Patent No.: 7,170,361 B1

For: METHOD AND APPARATUS OF
INTERPOSING VOLTAGE REFERENCE
TRACES BETWEEN SIGNAL TRACES IN
SEMICONDUCTOR DEVICES

REQUEST FOR CERTIFICATE OF CORRECTION OF PATENT
FOR APPLICANT'S MISTAKES (37 C.F.R. § 1.323) AND
PATENT OFFICE MISTAKES (37 C.F.R. § 1.322)

**Fig. 2
(PRIOR ART)**

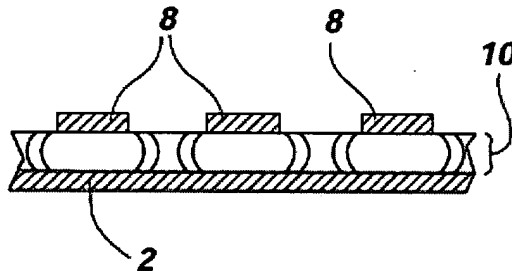
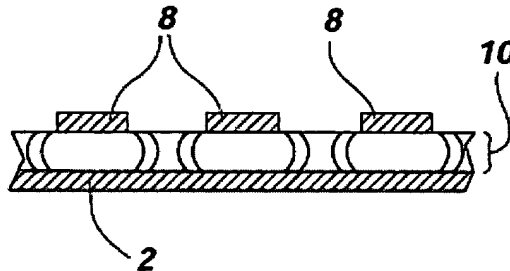
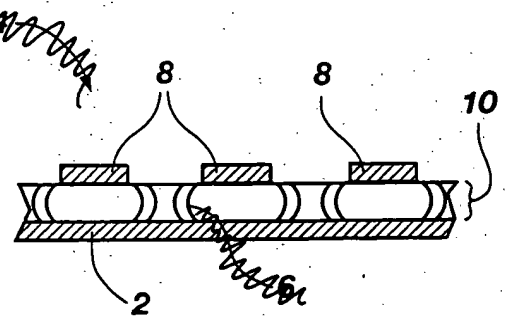
In amended Figure 2, the reference numerals "4" and "6" have been removed in order to eliminate redundancy with previously used reference numerals.

Fig. 4

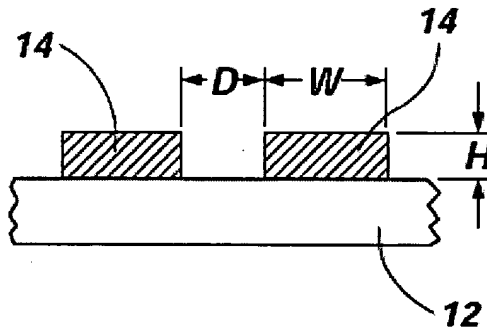
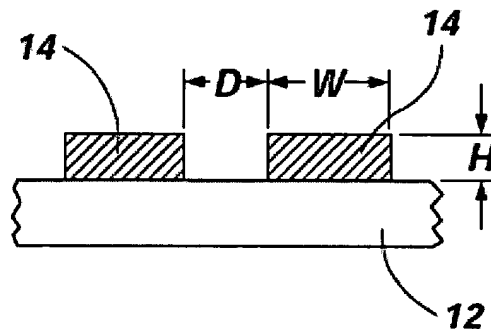
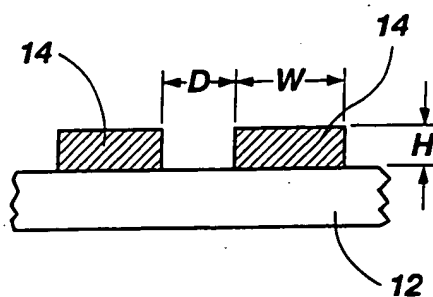
In the specification, paragraph [0028] has been amended to clarify the description of Figure 4. The phrase "between the upper surface of the substrate 12 and the upper surface of the

circuit trace 14," has been inserted after the phrase "and the height ("H")" to both clarify the term "H" and define substrate 12 as shown in Figure 4.

Fig. 11

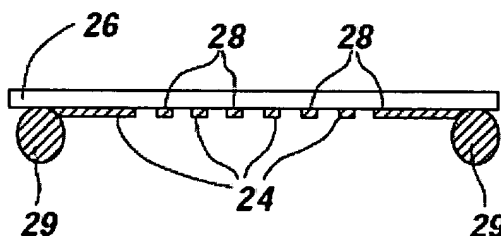
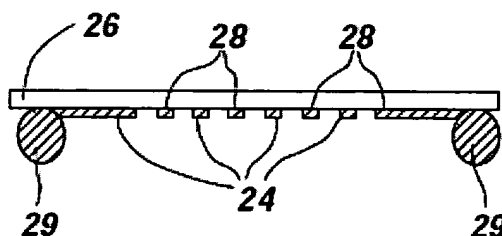
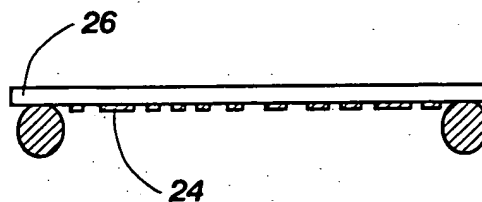
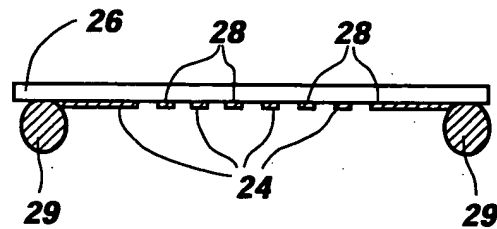
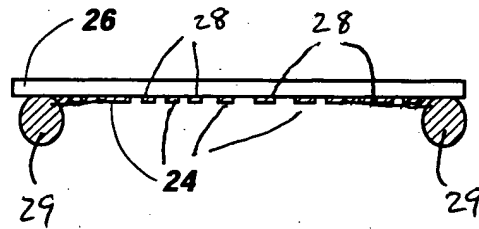
The attached sheet of drawings includes changes to FIG. 11. This sheet, which includes FIGS. 6-11, replaces the previous drawing sheet including FIGS. 6-11. In FIG. 11, the solder balls are shown as being connected to at least one signal and at least connected to the voltage reference signal, as suggested by the Examiner. (See attached Replacement Sheet and Annotated Sheet Showing Changes.)

“[t]he specification needs to provide an explicit description with respect to the FIG. 11 embodiment of the connection of the solder balls to at least one signal trace and the voltage reference signal as recited in amended claims 24 and 31. Since this amended limitation is considered not to be “new matter,” then an amendment to the fig. 11 adding the amended claim limitation would be appropriate.”

[0032] Figure 11 illustrates an embodiment of the present invention wherein circuit traces 24 are placed on the surface of a semiconductor substrate 26, more particularly, in a flip-chip ball grid array ("BGA") application. Like previous embodiments, the circuit traces 24 are configured such that a voltage reference trace 28 is placed between each of two signal traces 24 so that no signal trace 24 is placed immediately adjacent another signal trace 24. At least one of the solder balls 29 is operably coupled to at least one signal trace 24 and at least one solder ball 29 is operably coupled to a voltage reference trace 28.

Fig. 11 has been modified to show the solder balls being connected to at least one signal and at least connected to the voltage reference signal, as suggested by the Examiner.

Fig. 12

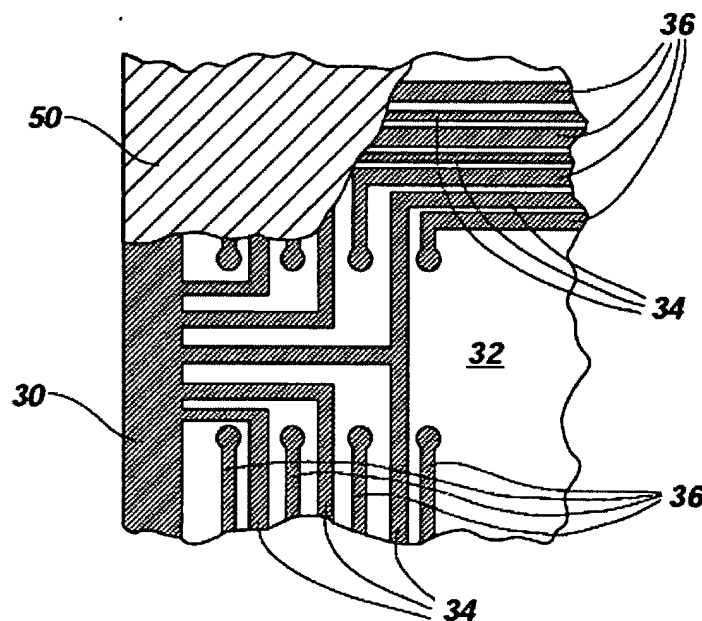
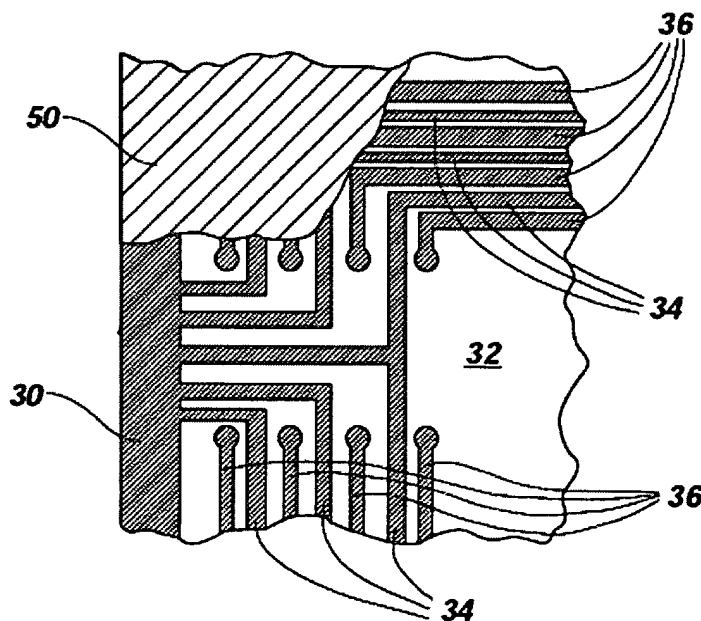
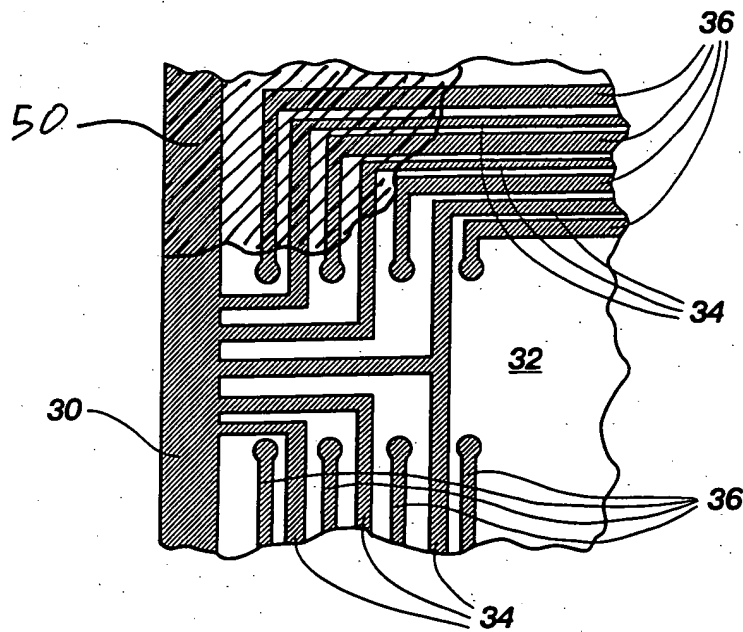
In amended Figure 12, as requested by the Examiner, a passivation layer as described in paragraph [0034] of the specification has been added and labeled with reference numeral "50."

Fig. 13

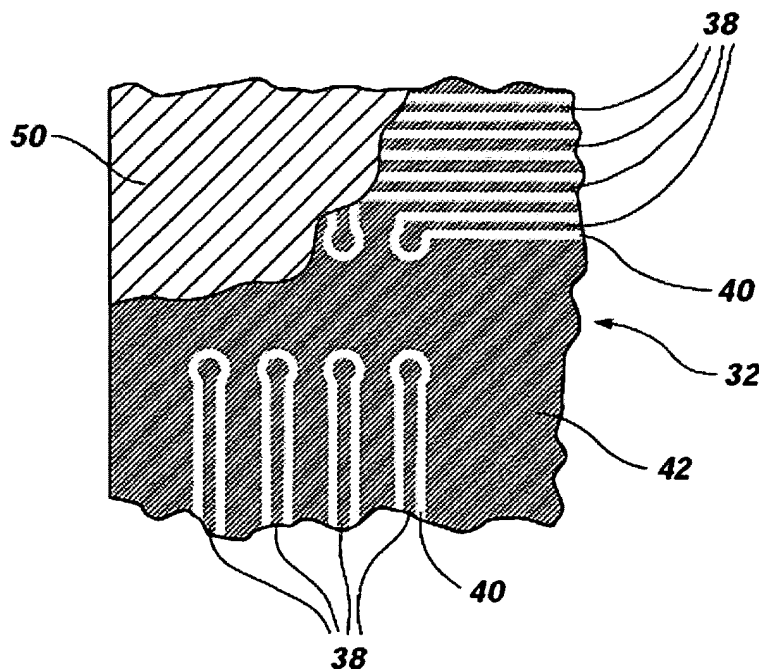
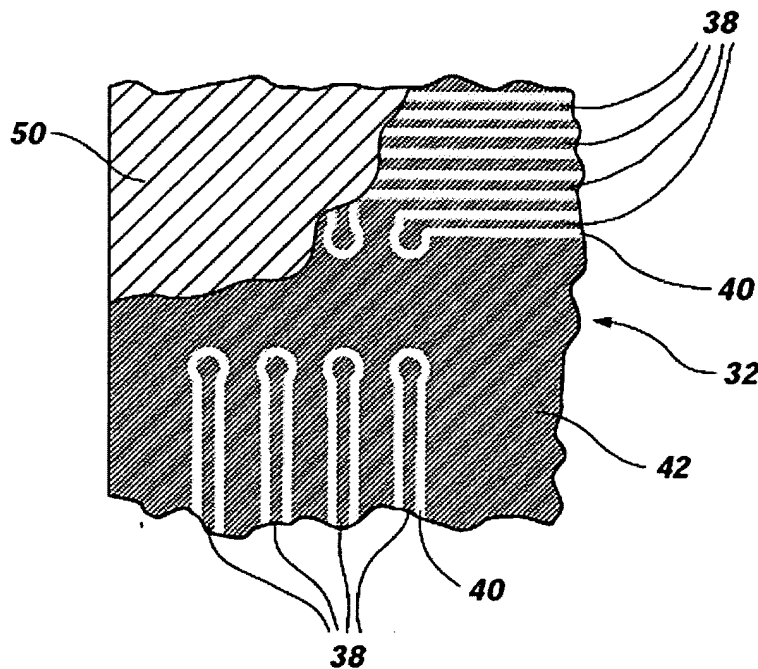
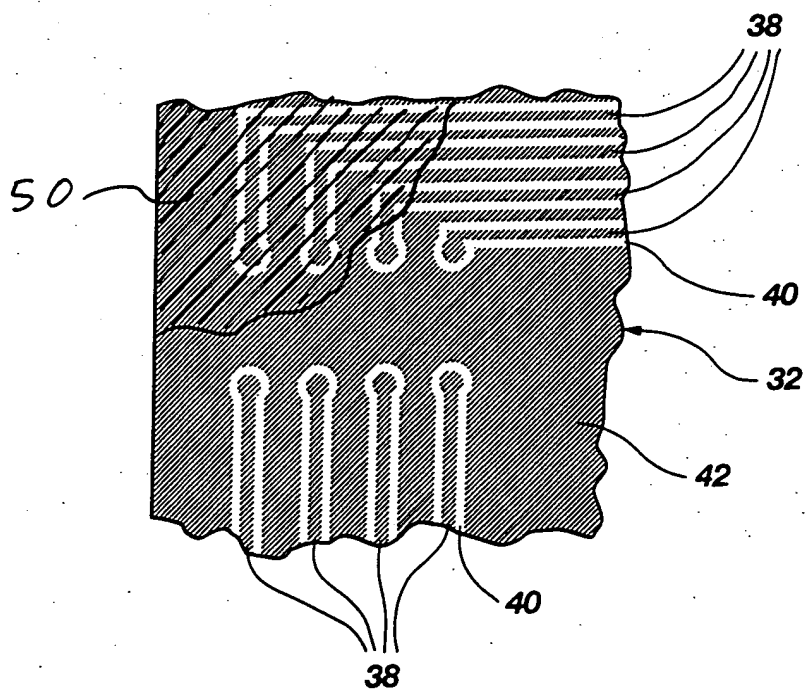
In amended Figure 13, as requested by the Examiner, a passivation layer as described in paragraph [0034] of the specification has been added and labeled with reference numeral "50."

"[i]t appears that the reference to the "semiconductor substrate" and "solder balls" relates to the embodiment depicted and describe relative to "figure 11", while the reference to the slotted voltage reference plane and isolated signal traces relate to the embodiment of "figure 13". However, there does not appear to be any disclosure in the original specification as to an embodiment combining the "semiconductor substrate/solder balls embodiment of "figure 11" with the slotted voltage reference plane/isolated signal traces embodiment of "figure 13"."

Applicants disagree with the Examiner's characterization that figure 11 and figure 13 necessarily represent different embodiments. In describing Fig. 13, the specification states at the second sentence of paragraph 0034 that "[a]s shown in Figure 13, a layer of conductive material on a **substrate 32** has been removed only around the coplanar signal traces 38. Methods of removing selected portions of conductive material from a substrate, such as by masking and etching, are well known in the art."

Fig. 8

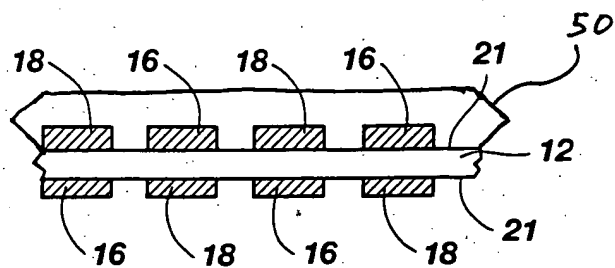
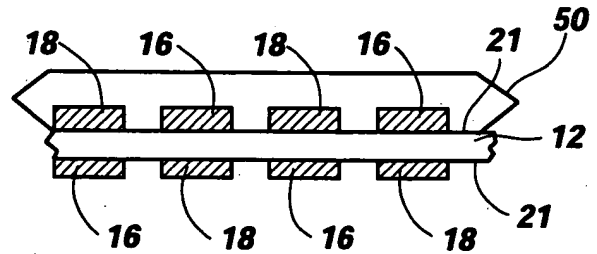
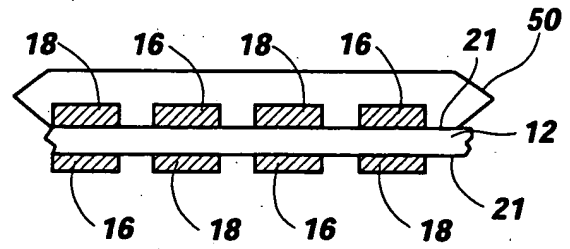
In amended Figure 8, as requested by the Examiner, a passivation layer as described in paragraph [0034] of the specification has been added and labeled with reference numeral "50."
